Addendum No. 002

**Subject:** Anna B. Day School – Fire Alarm System Replacement SDP  
Contract No. B-081C of 2018/19

**This Addendum, dated May 24, 2021, shall modify and become part of the Contract Documents for the work of this project. Any items not mentioned herein, or affected by, shall be performed strictly in accordance with the original documents.**

DRAWING NO.  
**ED - 100.0**  
SHEET **2** OF **8**

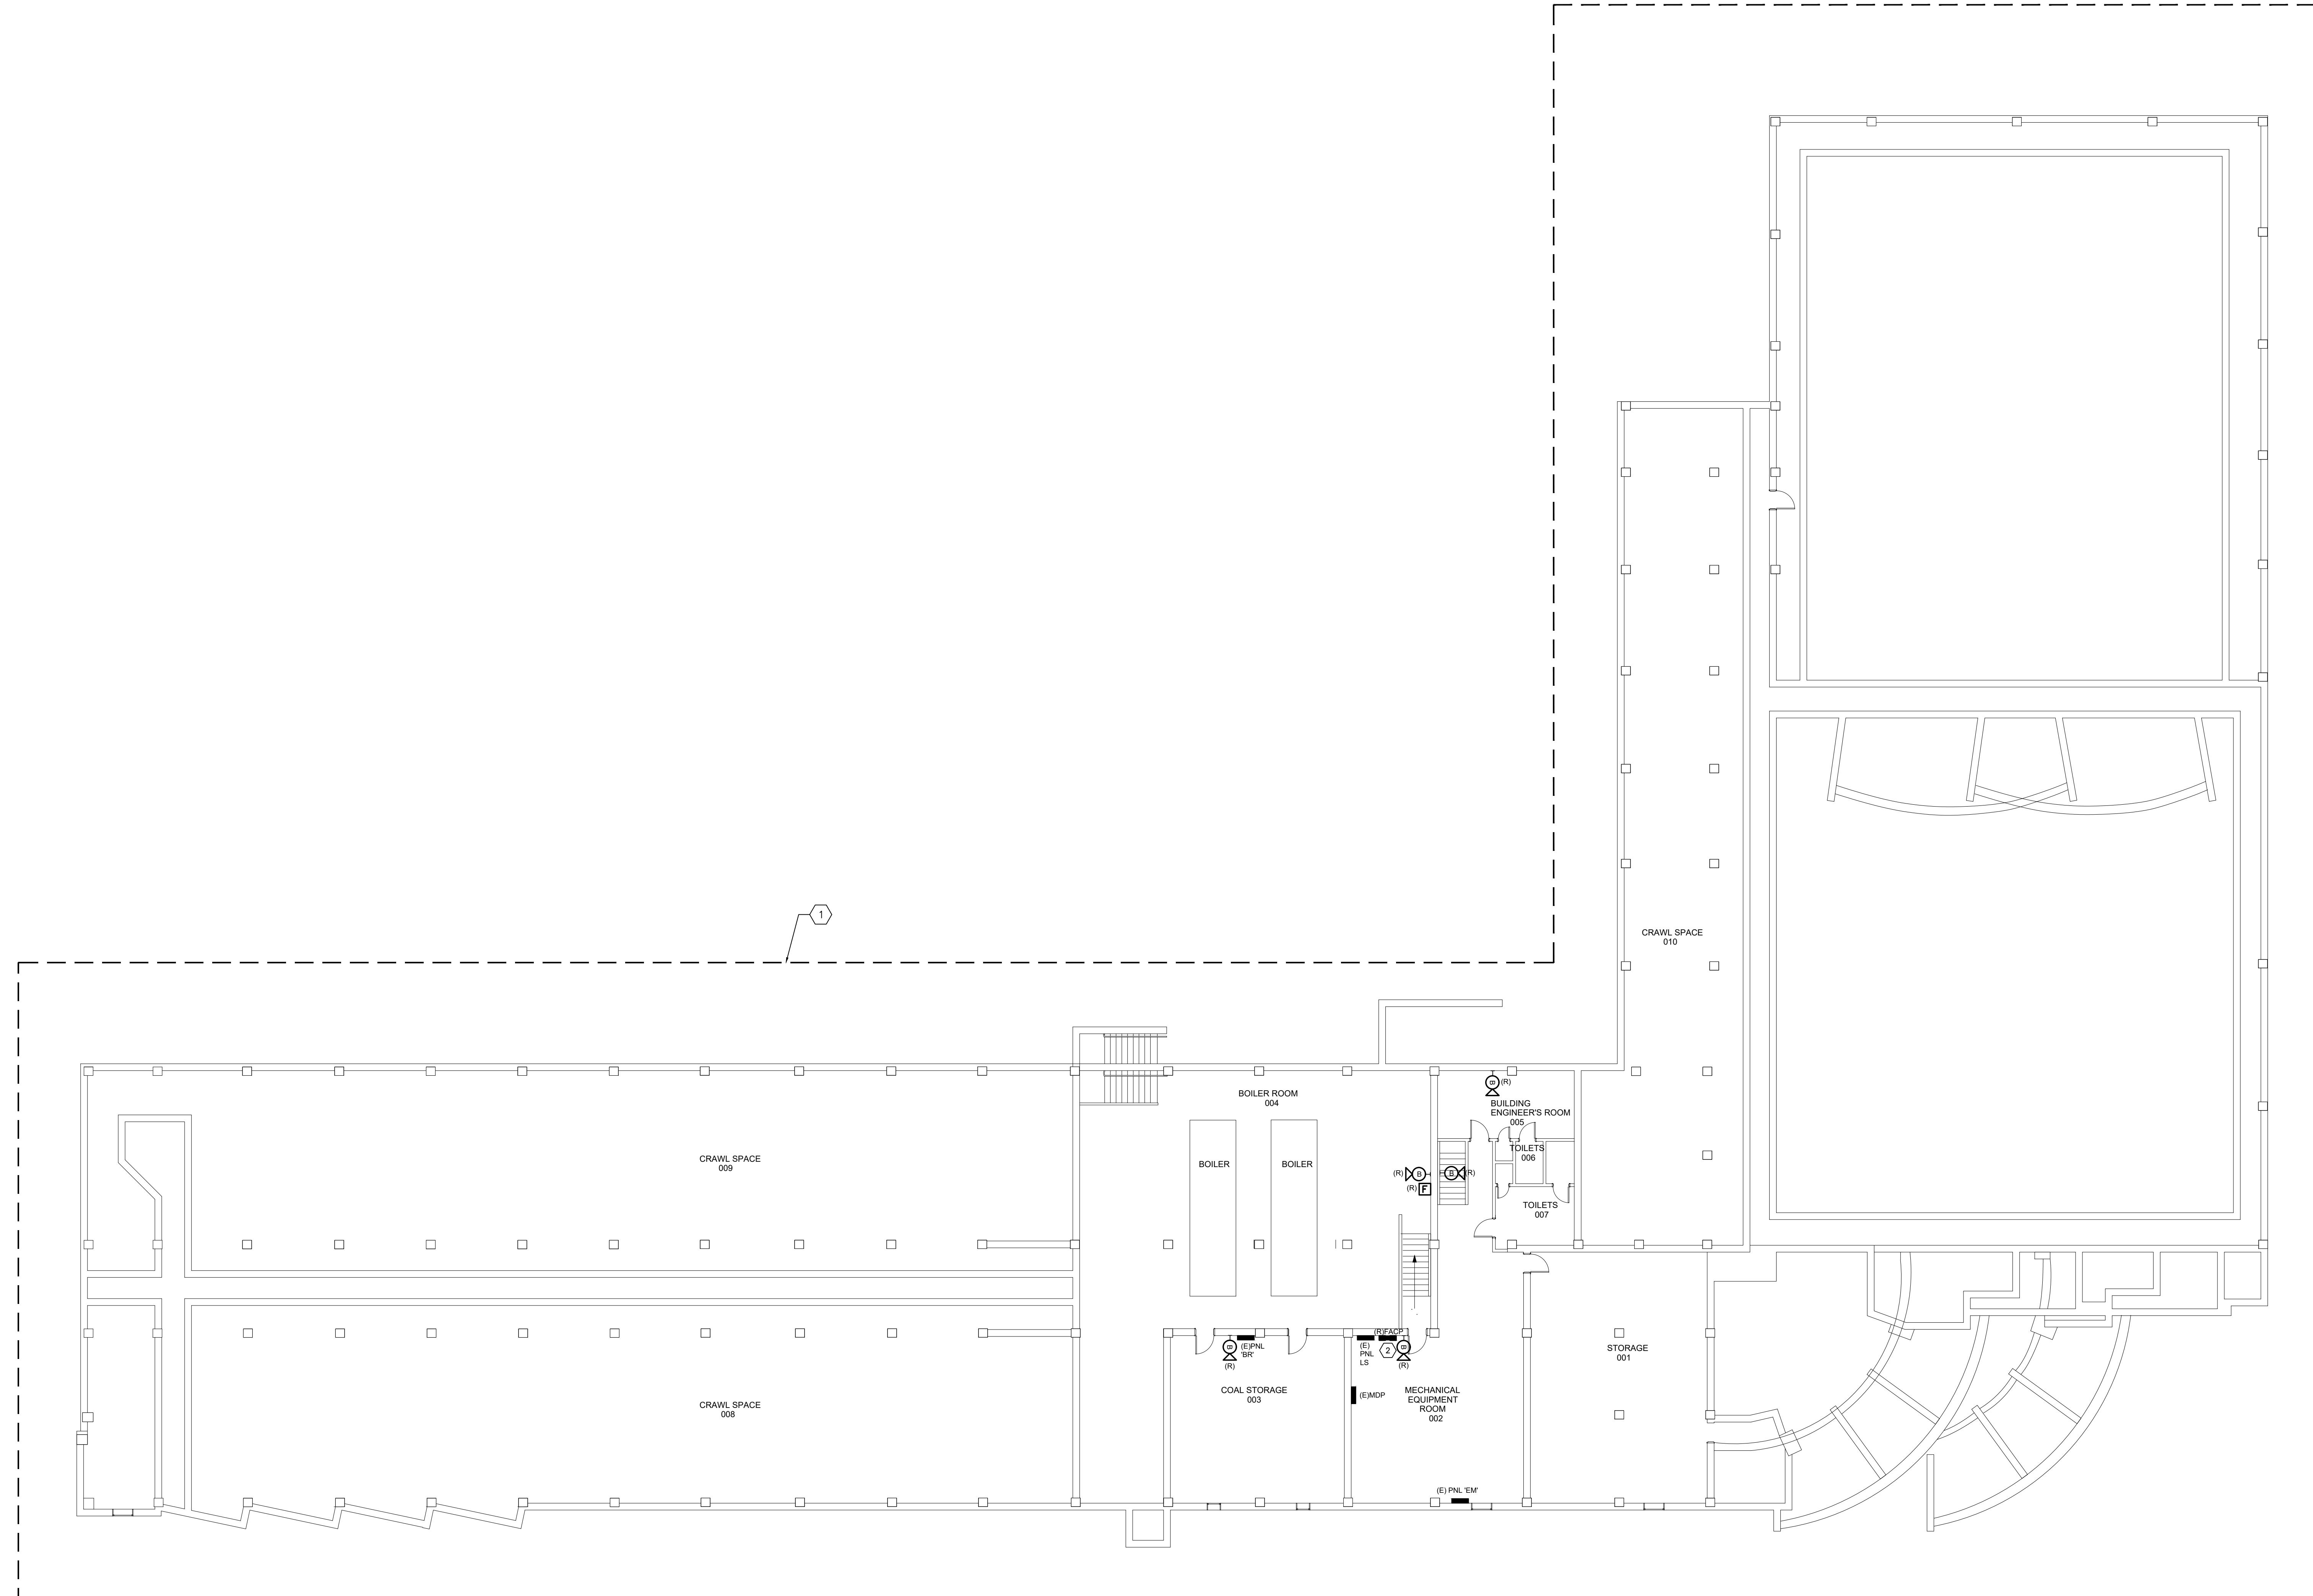
Question #1: Spec 011100 states that contact with asbestos containing materials is not anticipated for this project. General note A on drawing E-100.0 states to avoid asbestos containing materials per the provided report, and there should be no cost to the school district if devices need to be relocated to avoid asbestos containing materials. However, there may be instances where we cannot relocate and may need to abate, but this scope cannot be quantified until construction begins. Therefore, this note is unbidable. Please consider adding an allowance for asbestos abatement or removing the "no cost" portion of general note A.

Response – DELETE NOTE A ON DRAWING E-100 AND NOTE F ON DRAWINGS E-101 AND E-12, AS WELL AS NOTE F ON DRAWINGS ED-100, ED-101 AND ED-102.

DRAWING NO.  
**E - 100.0**  
SHEET 5 OF 8

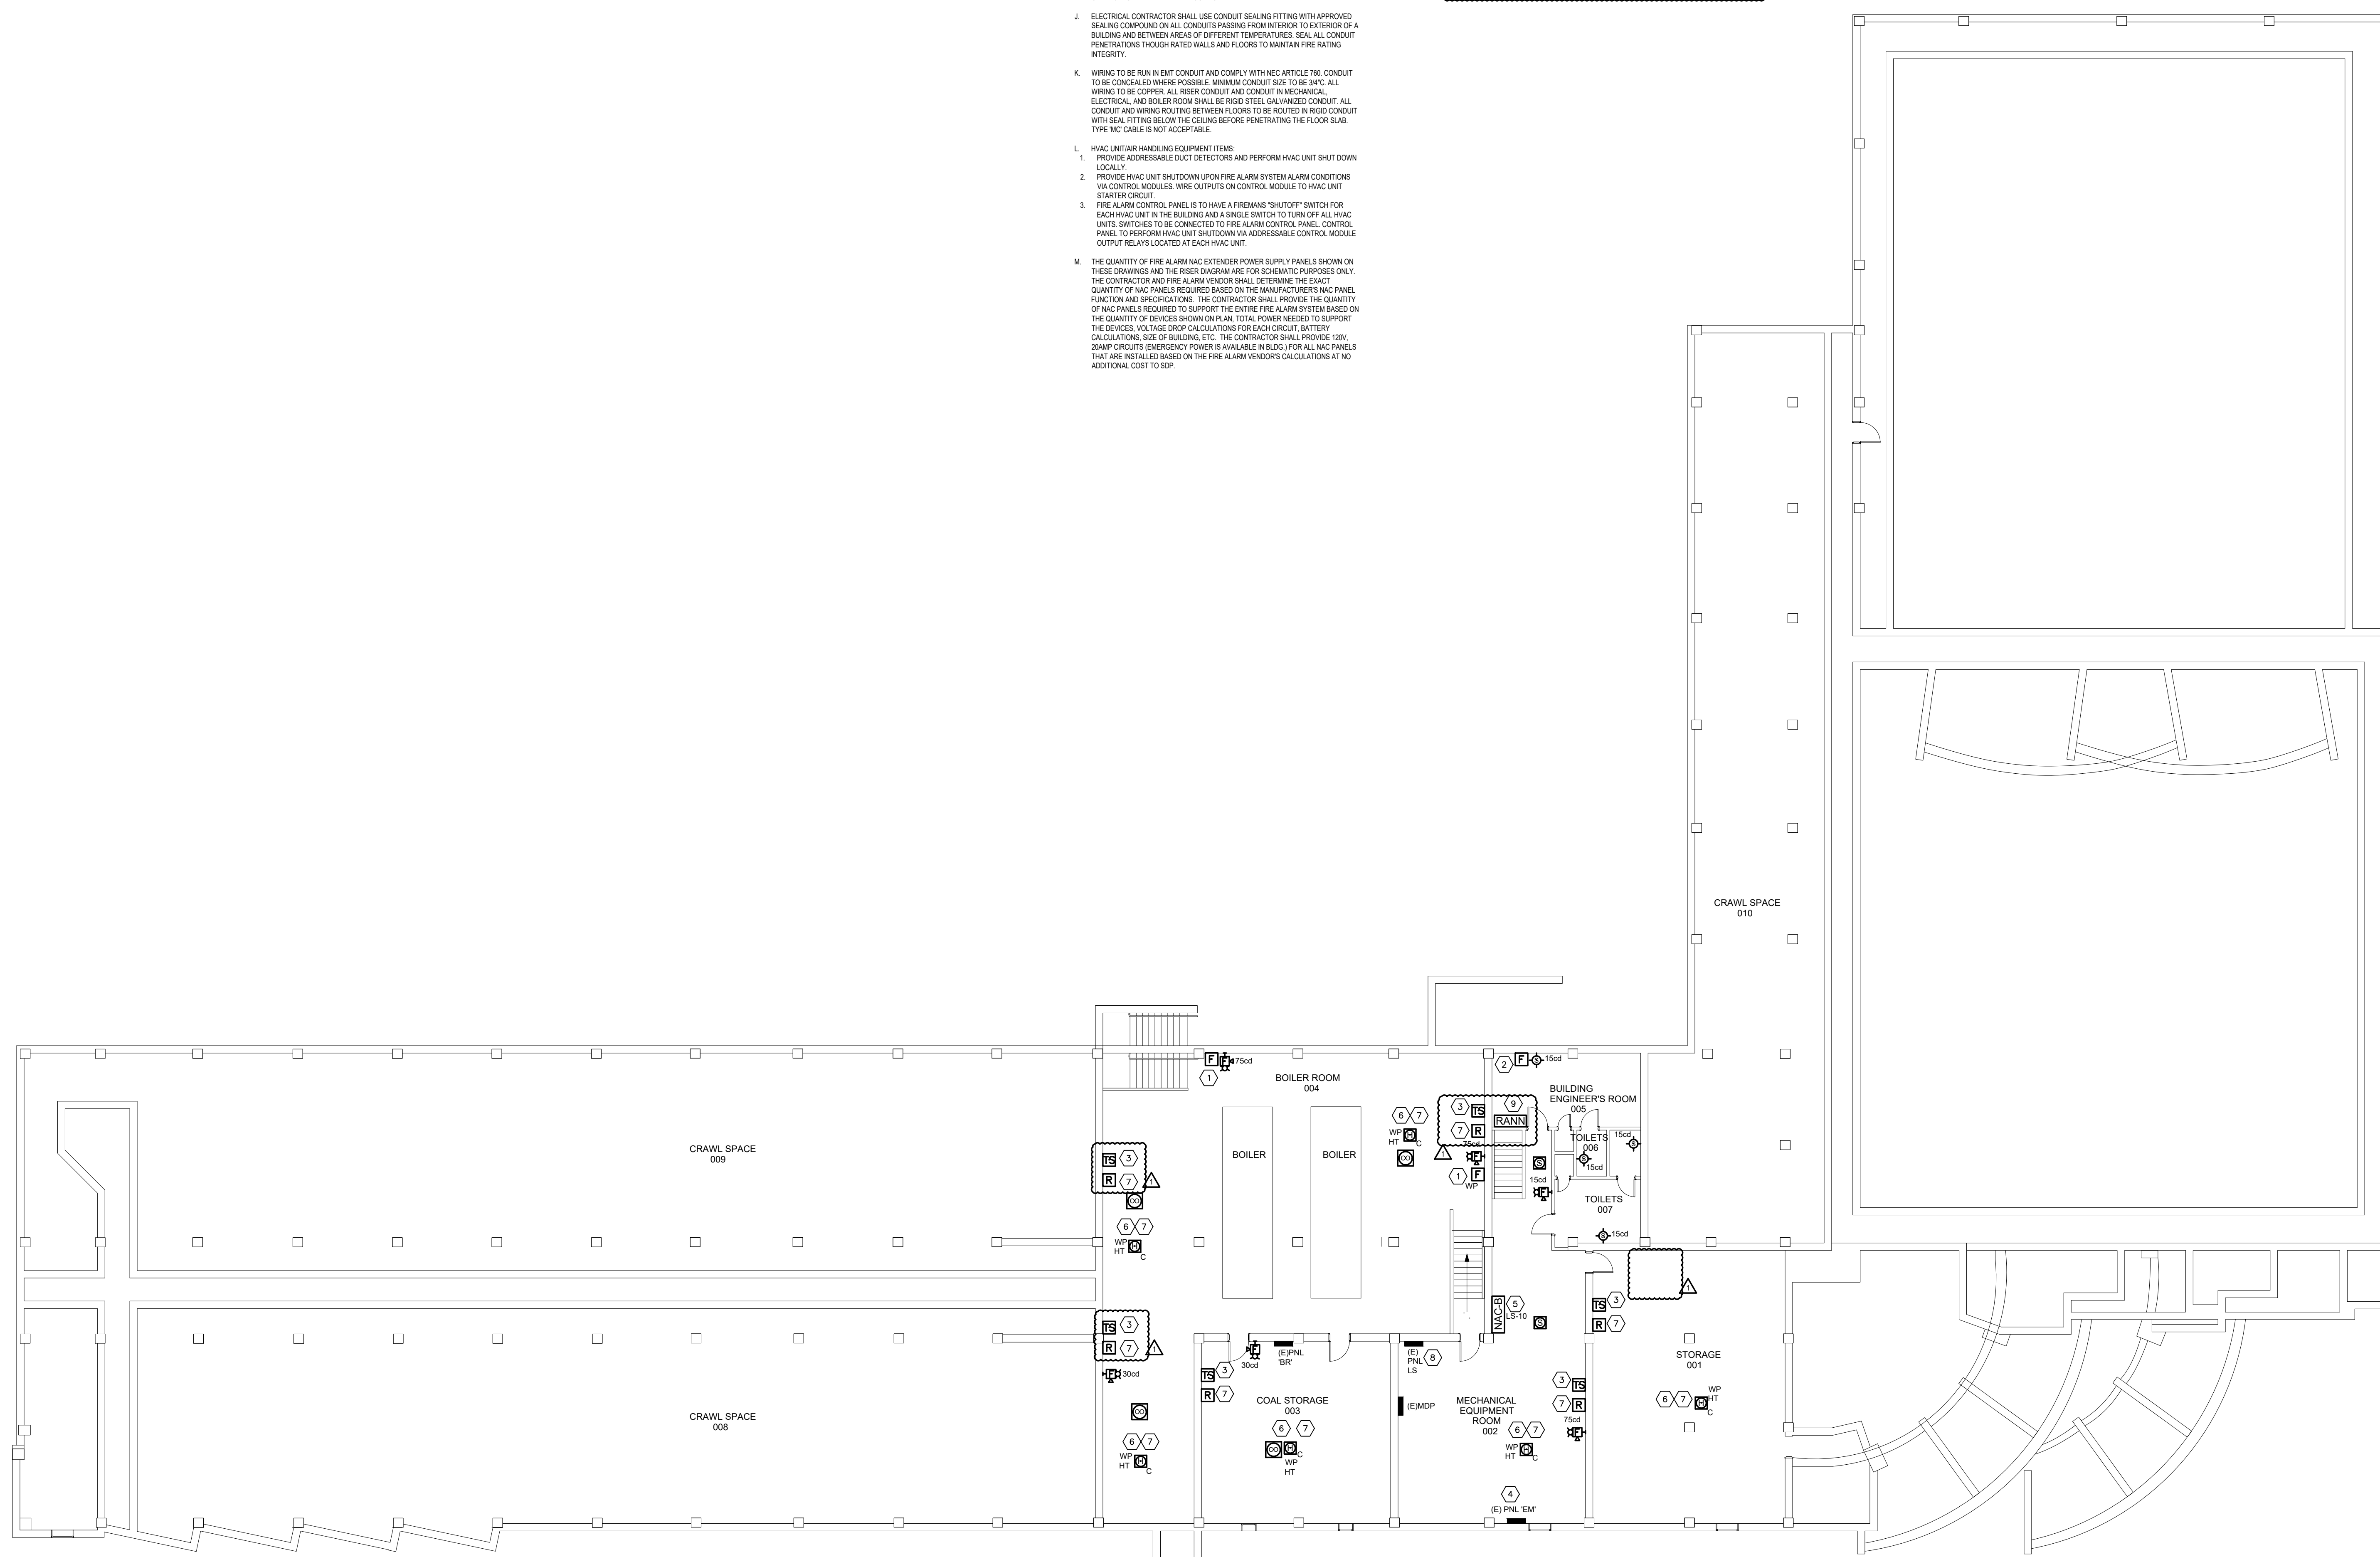
E100:

1. Updated quantity of test switches and heat detectors.
2. Added remote annunciator panel in engineer's office room 005

Question #2: Summary of work spec section 011000-1.3(4) states to provide a remote annunciator at the building engineer's office, but a remote annunciator is not shown in building engineer's room 005 on drawing E-100.0. Only 2 remote annunciators are shown in the riser diagram on E-501.0 (assuming for the main entrance and main office only). Please confirm a remote annunciator should be provided in the building engineer's office.

Question #6: The design intent of the quantity of test switches and monitor modules for non-addressable fire alarm devices on drawing E-100.0 (basement) is unclear. For example, Storage 001 shows (3) test switches & (3) monitor modules, but only (1) conventional heat detector. What conventional devices are the extra (2) test switches & extra (2) monitor modules associated with? There is a similar discrepancy in the Boiler Room 004 and Coal Storage 003. Please confirm the intent is to provide (1) test switch and (1) monitor module for each conventional heat detector, carbon monoxide detector, and weatherproof pull station in the basement.

Response – Provide 3<sup>rd</sup> annunciator in engineer's office room 005. See revised drawing E100.

Response – The quantity of test switches and monitor modules have been updated on the drawings. See revised drawing E-100. Yes, provide (1) test switch and (1) monitor module for each conventional heat detector, carbon monoxide detector, and weatherproof pull station in the basement.
